UNITED STATES PATENT AND TRADEMARK OFFICE

10/574,817

Office Action Summary	Application No. 10/574,817	Applicant(s) GOUJON ET AL.	
	Examiner ROBERT K. NICHOLS II	Art Unit 3754

DETAILED ACTION

Burt Marked Up Figure 2

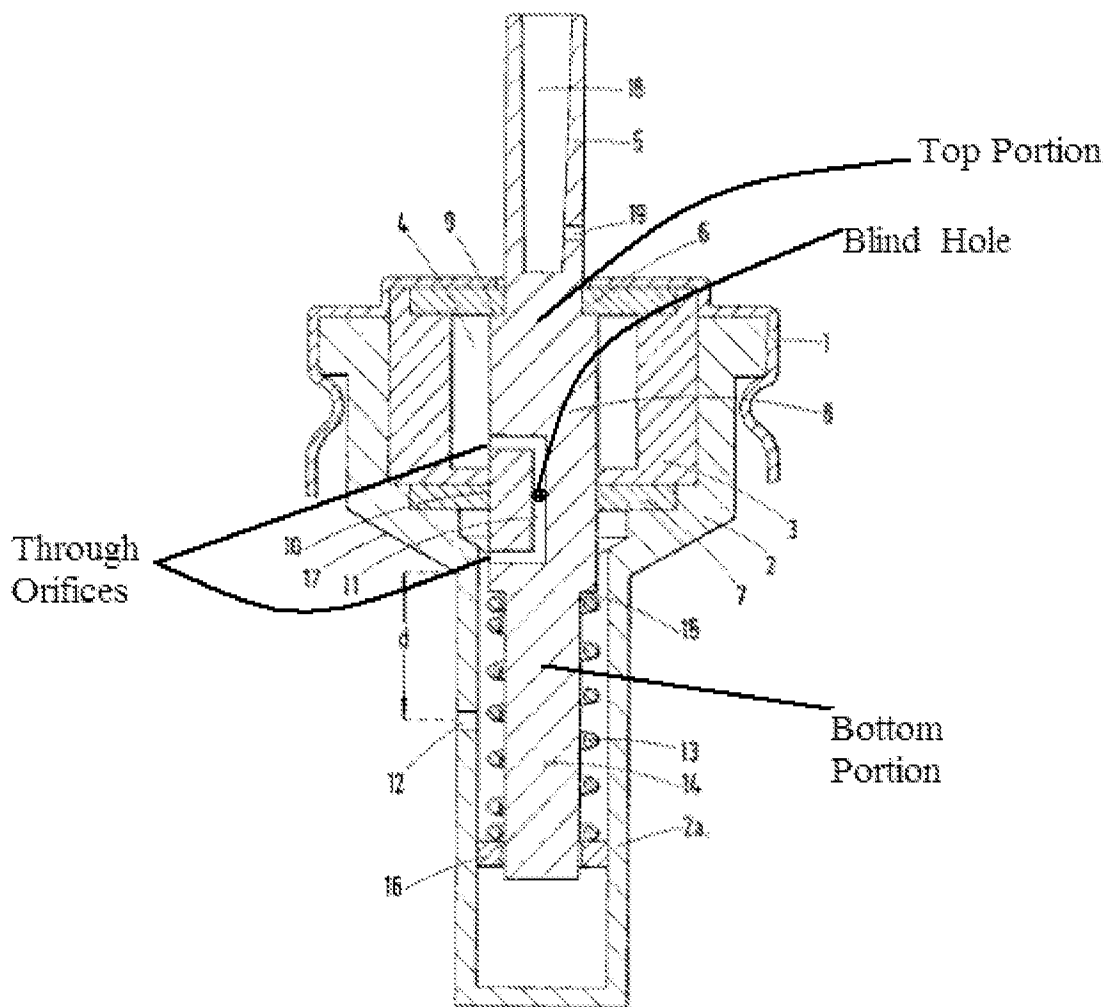
position and a dispensing position, the valve member 8 including a dispenser orifice 18, the valve being characterized in that it includes an axial guide element 16 that co-operates with a guided portion 14 of the valve member 8, the guided portion 14 being remote from the dispenser orifice 18, and in that the valve member includes a top portion including the dispenser orifice 18, and a bottom portion including the guided portion 14 (see marked-up figure 2).

Regarding claim 2, Burt discloses the guide element 16 being secured to the valve body 2, in particular by being made integrally therewith (see figure 2).

Regarding claim 3, Burt discloses the guide element 16 is a hollow sleeve having an inside diameter that is approximately equal to the outside diameter of the guided portion 14 of the valve member 8 that is slidable in the hollow sleeve 16 (see figure 2).

Regarding claim 4, Burt discloses the hollow sleeve 16 having a blind hollow (see figure 2).

Regarding claim 6, Burt discloses the valve being a metering valve including a metering chamber 4, the valve member 8 including a dispenser channel connecting the metering chamber 4 to the dispenser orifice 18 when the valve member 8 is in its dispensing position, and a filler channel 11 for filling the metering chamber 4 when the valve member 8 returns to its rest position (see marked-up figure 2 and column 4, lines 42-56).

Regarding claim 8, Burt discloses the bottom portion of the valve member 8 includes a blind hole including two lateral through orifices, with one orifice opening out into the metering chamber 4 when the valve member 8 is in its rest position, the top

portion of the valve member 8 being fitted in the blind hole so as to close said blind hole axially (see marked-up figure 2 and column 4, lines 42-56).

Regarding claim 9, Burt discloses the blind hole of the bottom portion of the valve member 8 forms a central axial channel that is connected to said two lateral orifices, thereby forming the filler channel 11 (see marked-up figure 2).

Warby Marked up Figure 1

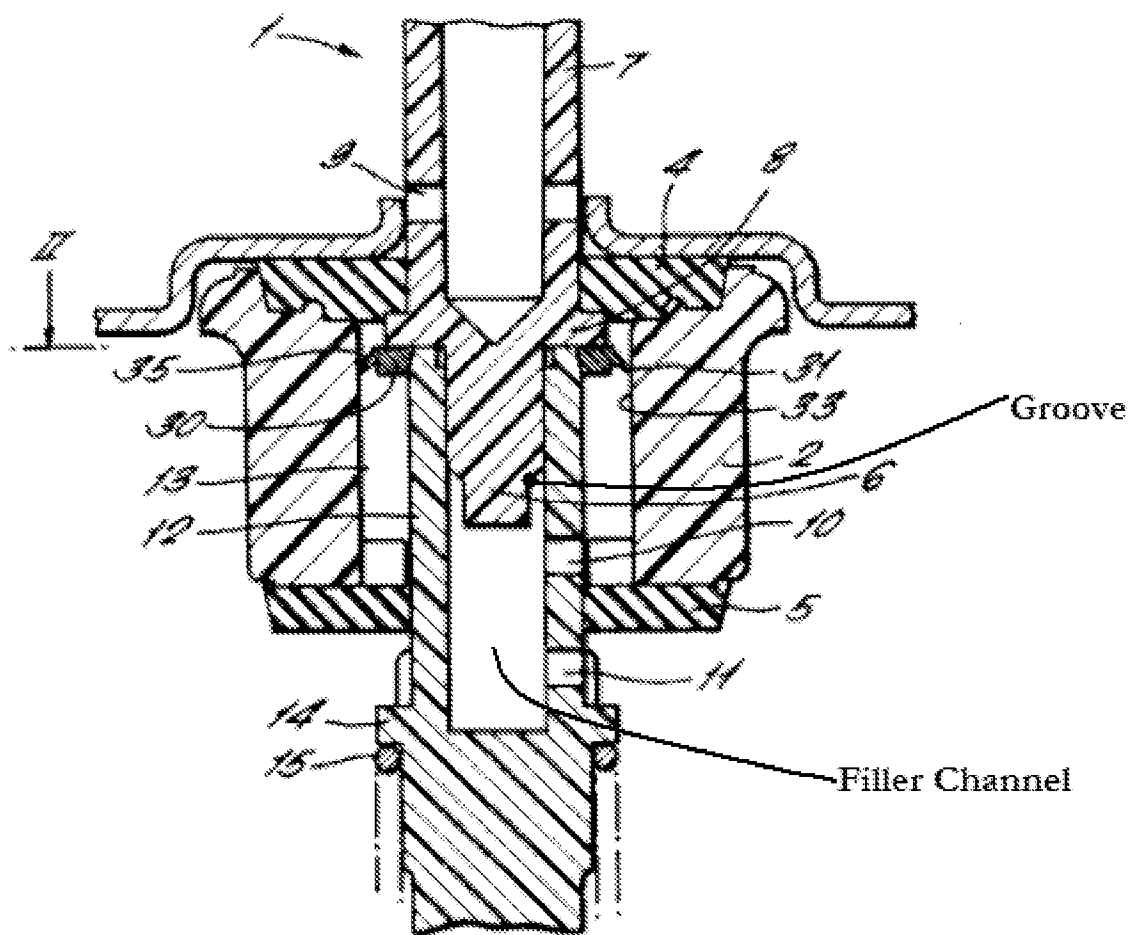
Warby teaches a fluid dispenser valve including a valve body 2, a valve member 1 that is slidable in the valve body 2 between a rest position and a dispensing position. Warby further discloses the valve member to include a top portion or upper end portion 7 including a dispensing orifice and a bottom or lower portion 12, wherein the top portion of the valve member 1 includes a groove that extends axially and that co-

operates with a blind hole of the bottom portion of the valve member 1 to define at least one portion of the filler channel. Warby additionally discloses the top portion 7 including a dispensing orifice and a bottom portion 12 being assembled one in the other (see marked-up figure 1).

It would have been obvious to one having ordinary skill in the art at the time the invention was made to have assembled the top and bottom portions of the Burt device

one in the other, since it has been held that constructing a formerly integral structure in various elements involves only routine skill in the art. *Nerwin v. Erlichman*, 168 USPQ 177, 179.
